Item Name: Crosstube Fwd High

DART AEROSPACE LTD	Work Order: 92708
Description: Crosstube High Fwd (205/212/412)	Part Number: D212-664-101
Inspection Dwg: D212-664-141 Rev: D	Page 1 of 1

DRAWING NO. D212-664-141	TITLE XTUBE ASSY (205/212/412 HI FWD)	REV. D	DART AEROSPACE LTD ENGINEERING ORDER		D.E.O. NO. D212-664-141-D-1	SHEET NO. SHEET 1 OF 2	SCALE NTS
DRAWN	CHECKED	MFG. APPR.	APPROVED	DE APPR.			
DATE 11.04.07	DATE 11.04.11	DATE 11.04.12	DATE 11/04/12	DATE 11.04.12

ADD AN INSPECTION WINDOW TO UNDERSIDE OF CROSSTUBE.

**D212-664-141/-141B
ASSEMBLY DETAIL**

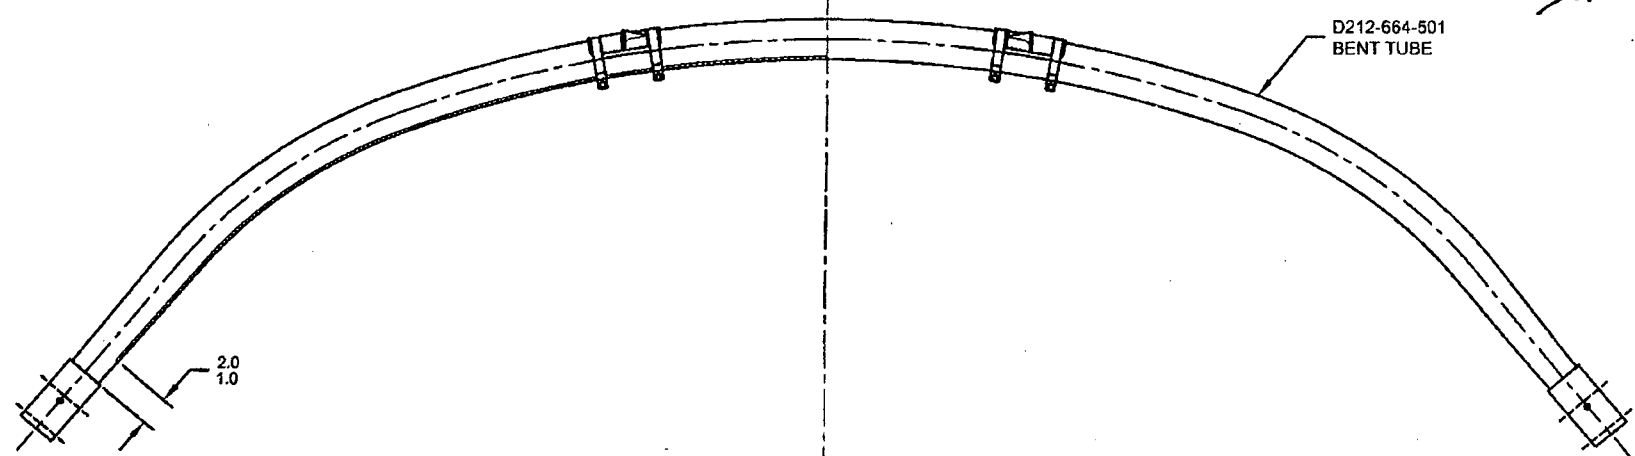
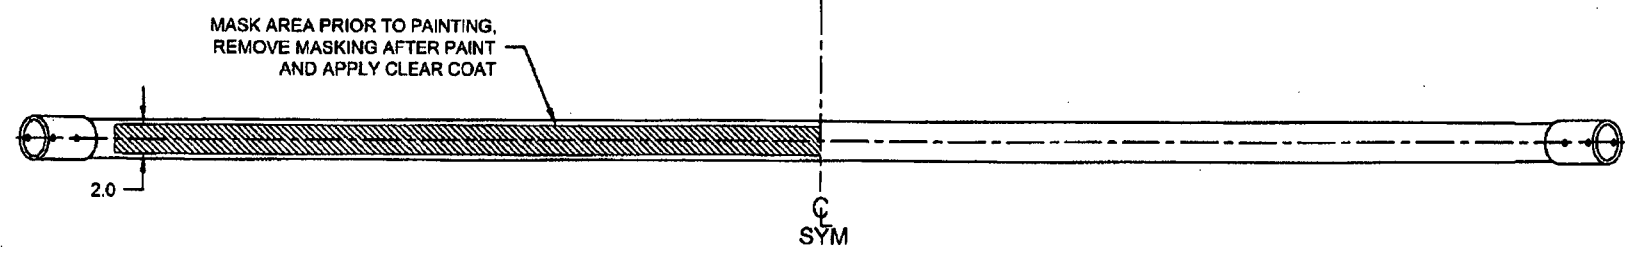
NOTES 2 OF SHEET 1 IS AMENDED AS FOLLOWS:

- 2) FINISH: CHEMICAL CONVERSION COAT PER DART QSI 005 4.1
PRIME INSIDE AND OUTSIDE PER DART QSI 005 4.2
MASK UNDERSIDE OF CROSSTUBE AS SHOWN (HATCHED AREA) AND
PAINT OUTSIDE PER DART QSI 005 4.2
REMOVE MASKING AND APPLY CLEAR COAT

IS:

WAS:
